UNITED STATES PATENT AND TRADEMARK OFFICE

APPLICATION NO.	FILING DATE	FIRST NAMED INVENTOR	ATTORNEY DOCKET NO.	CONFIRMATION NO.
09/940,949	08/28/2001	Luc Tripod	PU010180	5192

Office Action Summary

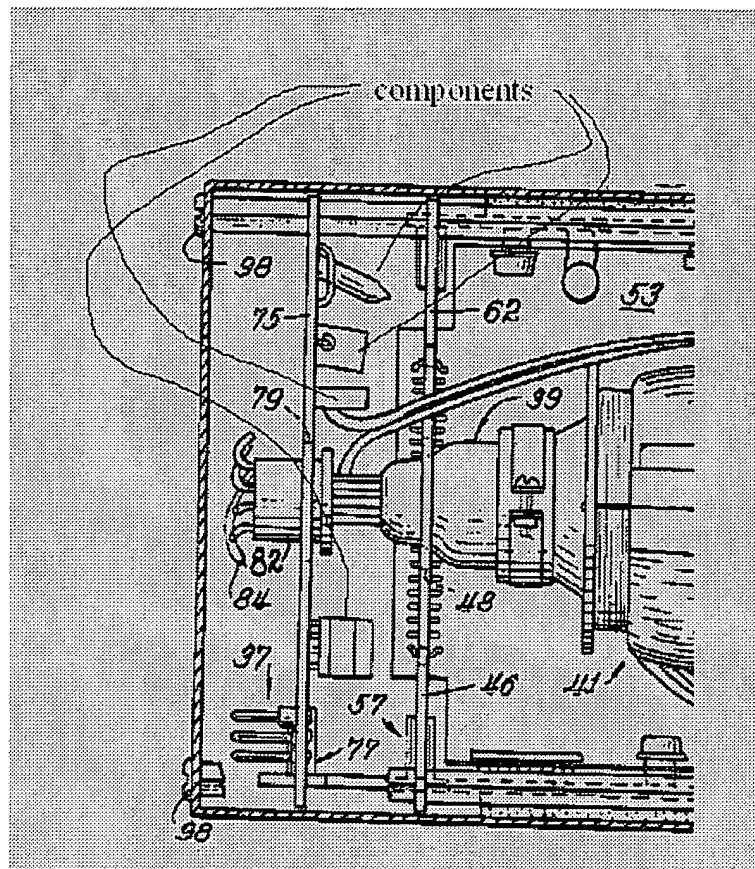
-- In reference to claims 2 and 8, Puhak shows substantially the invention as claimed. However, Puhak does not show the circuit board has a plurality of components mounted thereon, none of the components extending away from the funnel further than the back cover of the socket.

Johnson shows (cover sheet) the circuit board 75 has a four (a plurality) components (see examiner's figure) mounted thereon, none of the four components extending away from the funnel further than the back cover of the socket.

-- In reference to claim 3, Puhak as modified by Johnson shows (figure 8) the circuit board has a plurality of components (see examiner's figure) mounted on the first side.
